NEW BERN STATION AREA PLAN

Plan Amendments
Draft October 2017

Map 5: Streetscape Cross Section Key

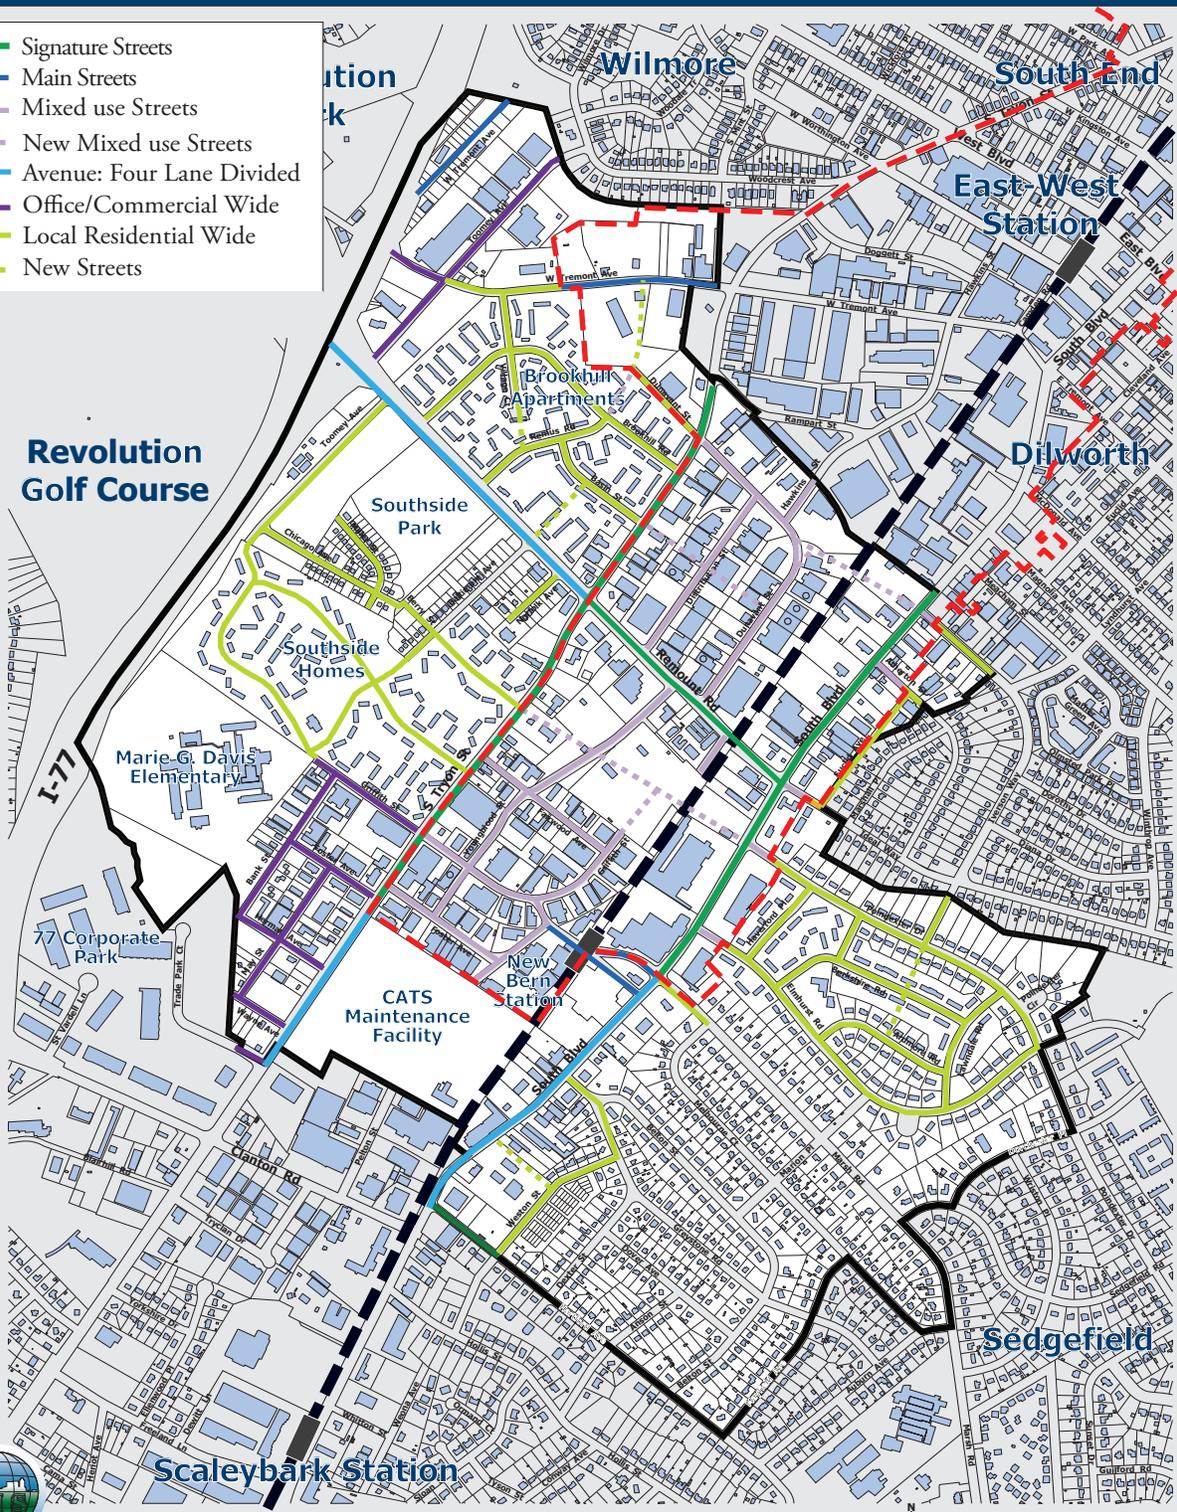
- Signature Streets
- Main Streets
- Mixed use Streets
- - - New Mixed use Streets
- Avenue: Four Lane Divided
- Office/Commercial Wide
- Local Residential Wide
- - - New Streets

**PAGE 19
PROPOSED**

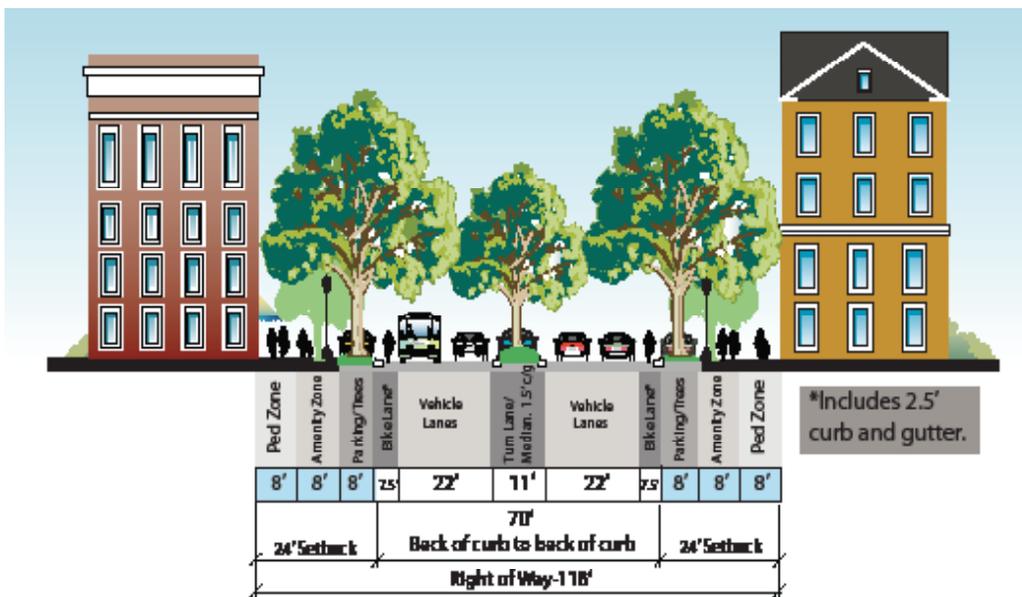
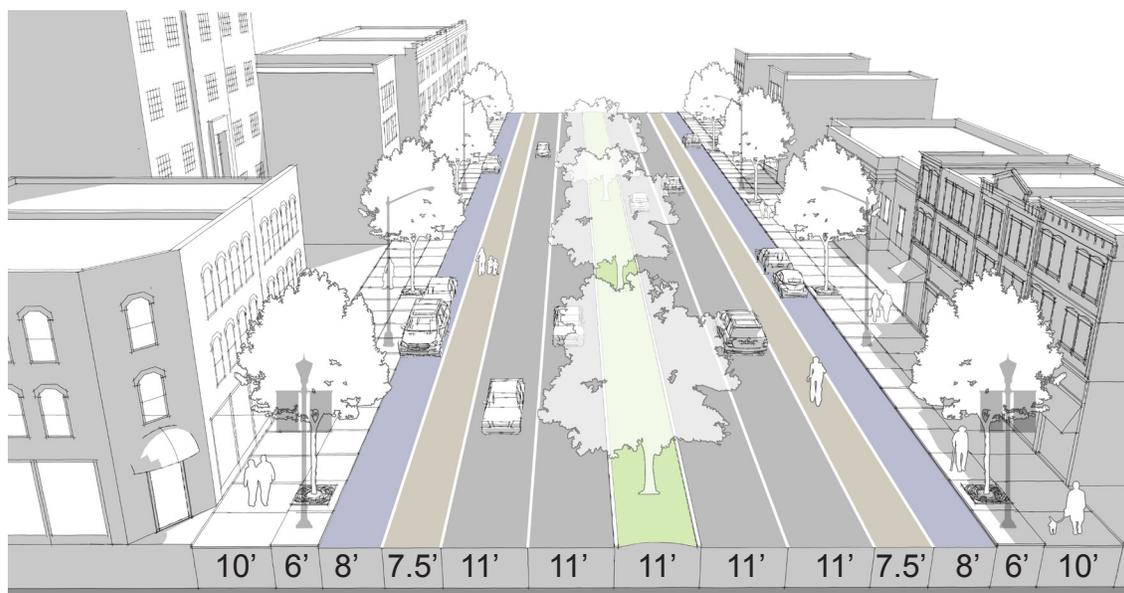
- ~~Planting strip or recessed on-street parallel parking serve as buffer from traffic to pedestrians on sidewalk. The recessed parking is required in all locations feasible under CDOT standards, with intermittent planter islands to break up parking into bays no more than 100 feet in length. Planting strip with trees is required in all other situations. South Tryon Street is a state highway, and current state regulations do not permit on-street parking. If circumstances change in the future such that on-street parking would be allowable, on-street parking would be required for further development projects per zoning standards.~~

- Recessed on-street parallel parking serve as buffer from traffic to pedestrians on sidewalk. The recessed parking is required in all locations feasible under CDOT standards, with intermittent planter islands to break up parking into bays no more than 100 feet in length. **An amenity zone with curbed planters or tree grates is required between the on-street parking and sidewalk.** If circumstances change in the future such that on-street parking would be allowable, on-street parking would be required for further development projects per zoning standards.

- Amenity zone provides supplemental tree planting location. Trees in the amenity zone should be planted in curbed planters **or tree grates (tree grates are required with ground floor commercial uses).** The amenity zone also provides additional paved area for street furniture, paved access to on-street parking, and merchandising purposes.

Signature Street | Remount Rd. |
Avenue - Two Lane Divided

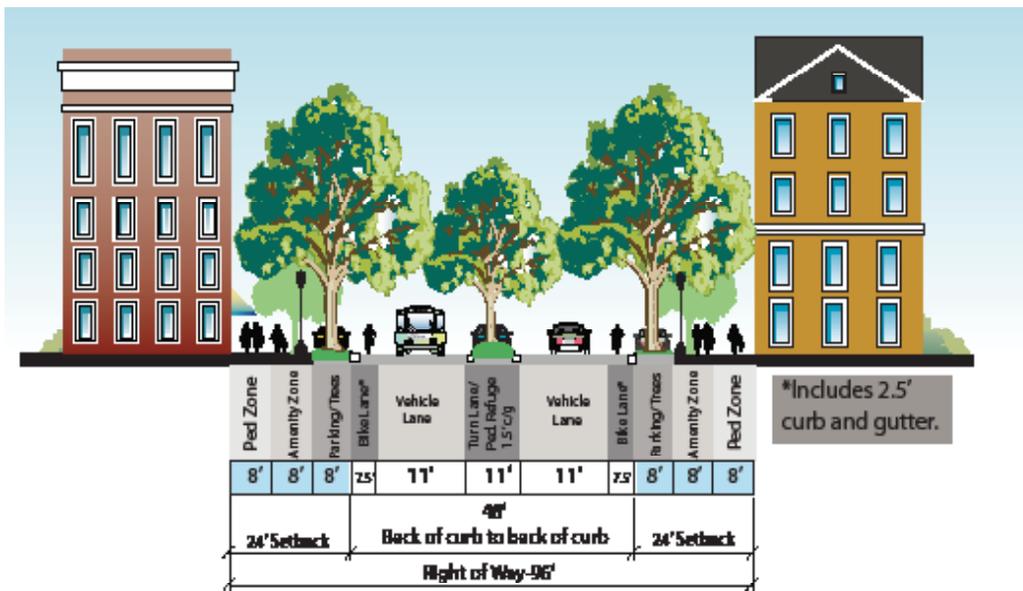
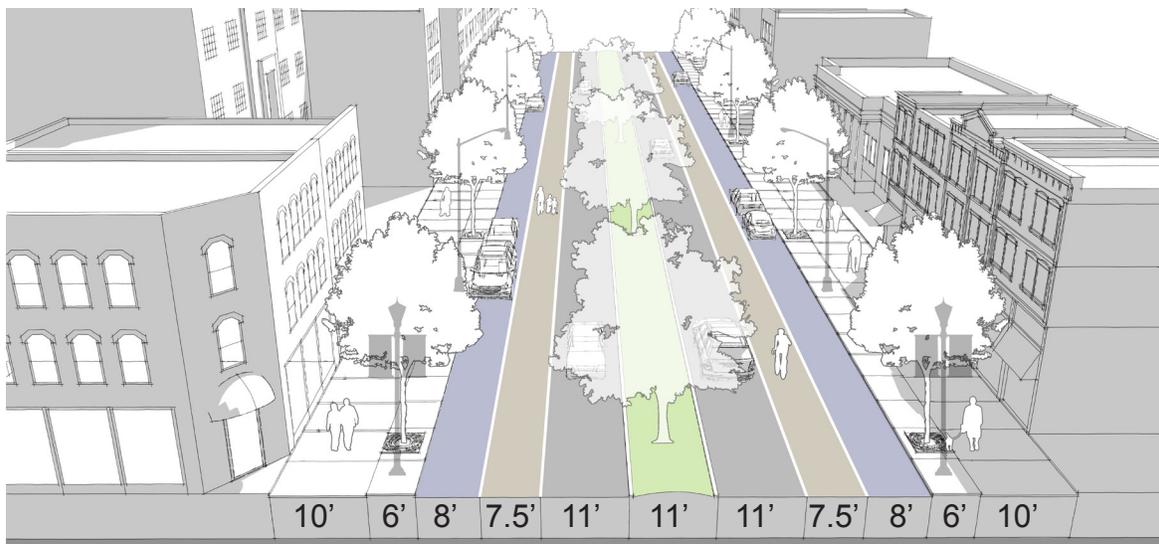
- ~~Planting strip or~~ recessed on-street parallel parking serve as buffer from traffic to pedestrians on sidewalk. The recessed parking is required in all locations feasible under CDOT standards, with intermittent planter islands to break up parking into bays no more than 100 feet in length. ~~Planting strip with trees is required in all other situations.~~

- Amenity zone provides supplemental tree planting location. Trees in the amenity zone should be planted in ~~curbed planters~~. The amenity zone also provides additional paved area for street furniture, paved access to on-street parking, and merchandising purposes.

- Ped Zone is the usual location for the clear sidewalk. Where there is no on-street parking and ~~planting strips are in place~~, the clear sidewalk can be pushed into the amenity zone location, and the ped zone can be used for landscaping, sidewalk dining, or paved merchandising purposes. Encroachments into the ped zone for features such as steps and open porches are allowed in accordance with the zoning ordinance, but encroachments at grade may not reduce the clear sidewalk to less than 8 feet.

- Recessed on-street parallel parking serve as buffer from traffic to pedestrians on sidewalk. The recessed parking is required in all locations feasible under CDOT standards, with intermittent planter islands to break up parking into bays no more than 100 feet in length. **Tree grates per CLDSM** are required in all other scenarios.

- Amenity zone provides supplemental tree planting location. Trees in the amenity zone should be planted in **tree grates per Charlotte Land Development Standards Manual (CLDSM)** The amenity zone also provides additional paved area for street furniture, paved access to on-street parking, and merchandising purposes.

Main Street

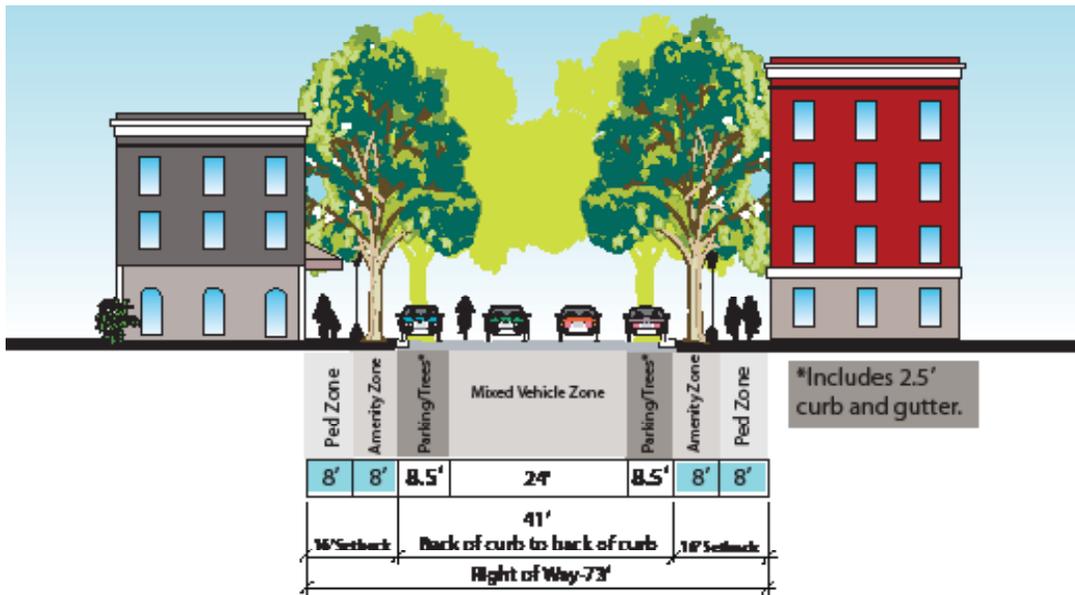
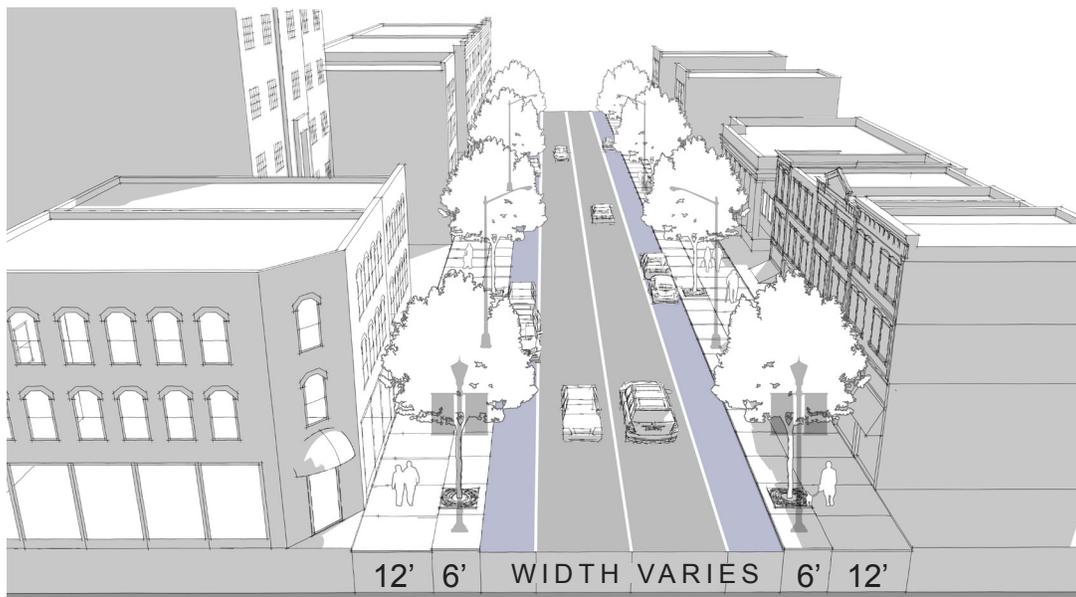
- ~~Planting strip or recessed on-street parallel parking serve as buffer from traffic to pedestrians on sidewalk. The recessed parking is required in all locations feasible under CDOT standards, with intermittent planter islands to break up parking into bays no more than 100 feet in length.~~

- Amenity zone provides supplemental tree planting location. Trees in the amenity zone should be planted in ~~curbed planters where planting strip is not in place.~~ The amenity zone also provides additional paved area for street furniture, paved access to on-street parking, and merchandising purposes.

- Ped zone is the usual location for the clear sidewalk. Where there is no on-street parking and ~~planting strips are in place,~~ the clear sidewalk can be pushed into the amenity zone, and the ped zone can be used for landscaping, sidewalk dining, or paved merchandising purposes. Encroachments into the ped zone for features such as steps and open porches are allowed in accordance with the zoning ordinance, but encroachments at grade may not reduce the clear sidewalk to less than 8 feet.

Proposed Behind the Curb: Minimum building setback is 18 feet from back of recommended recessed curb. Tree planting is required with spacing, irrigation, subdrainage, and adequate soil space for roots per the Charlotte Tree Ordinance.

- On-street parallel parking serves as buffer from traffic to pedestrians on sidewalk. The recessed parking is required in all locations feasible under CDOT standards, with intermittent planter islands to break up parking into bays no more than 100 feet in length.

- Amenity zone provides supplemental tree planting location. Trees in the amenity zone should be planted in tree grates per CLDSM. The amenity zone also provides additional paved area for street furniture, paved access to on-street parking, and merchandising purposes.

Office / Commercial Street - Wide

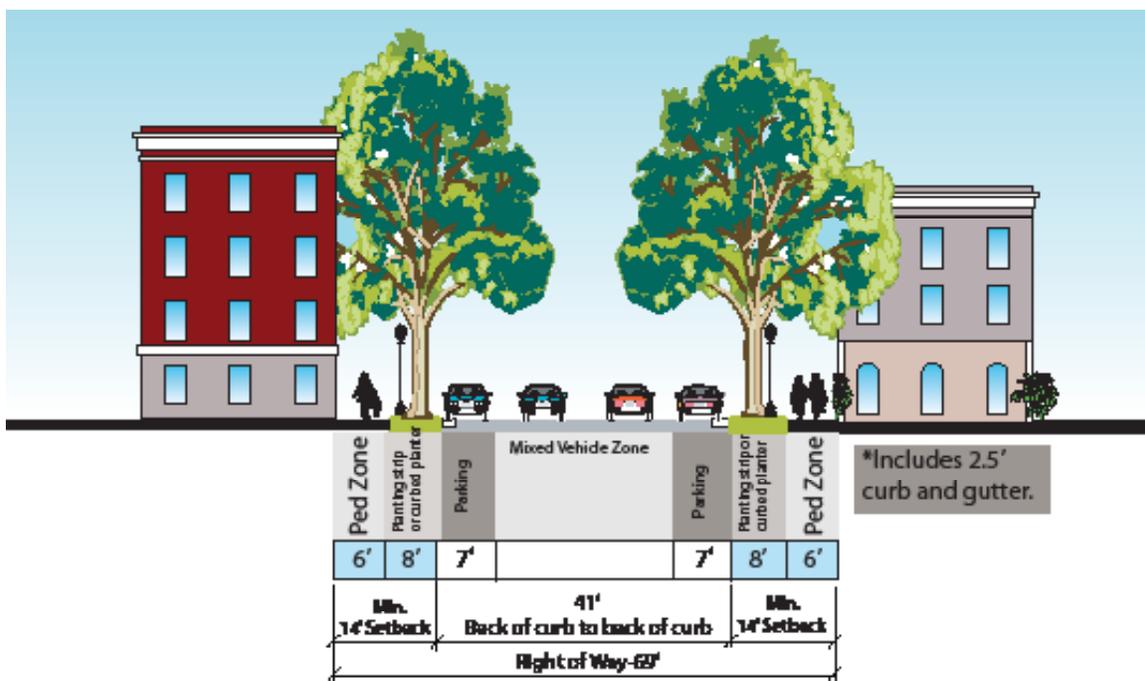
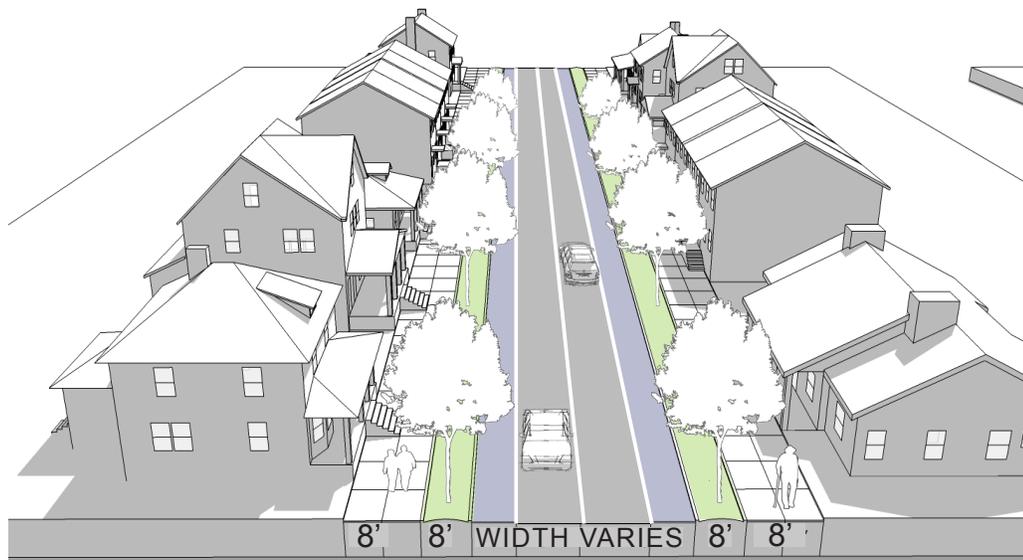
Proposed Behind the Curb: Minimum building setback is 14 feet from back of (recessed) recommended curb, or 21 feet from back of any extended curb. Tree planting is required with spacing, irrigation, subdrainage, and adequate soil space for roots per the Charlotte Tree Ordinance.

Proposed Behind the Curb: Minimum building setback is 16 feet from back of (recessed) recommended curb, or 21 feet from back of any extended curb. Tree planting is required with spacing, irrigation, subdrainage, and adequate soil space for roots per the Charlotte Tree Ordinance.

Local Residential Street - Wide

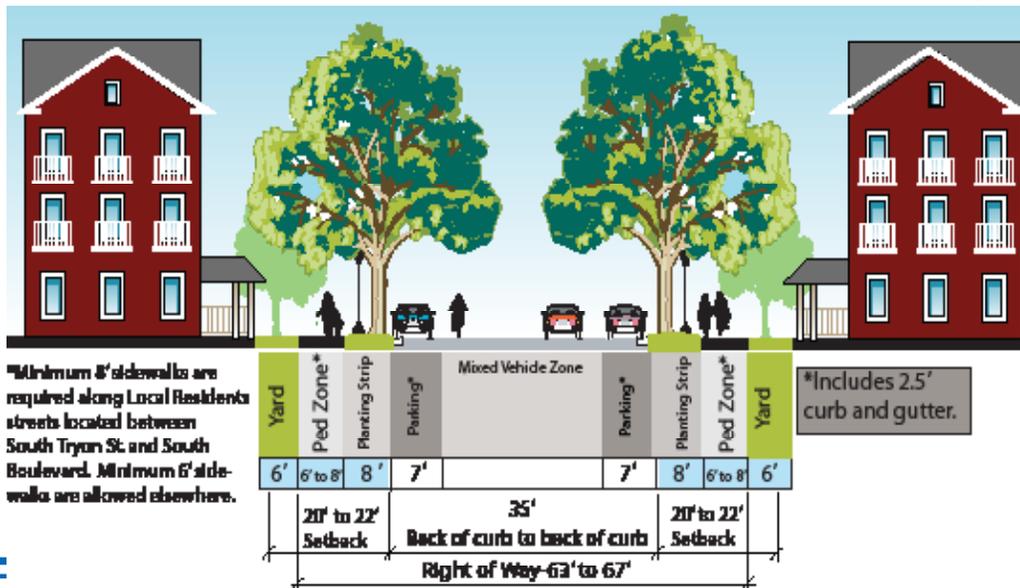
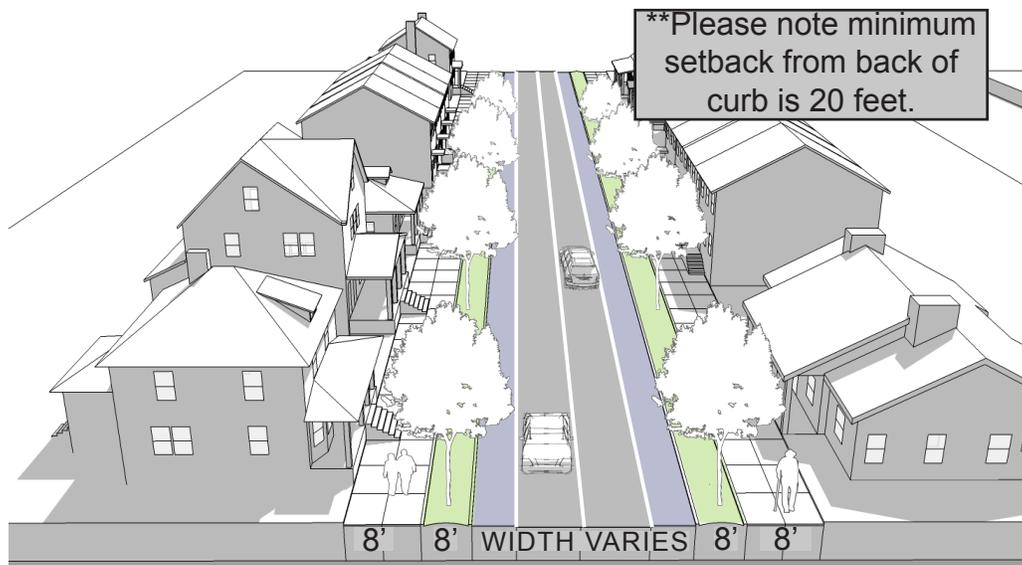
- Planting strip provides buffer from traffic to pedestrians on the sidewalk, and a landscaping opportunity. In locations with retail frontage or other high density applications, **tree grates will be required.**
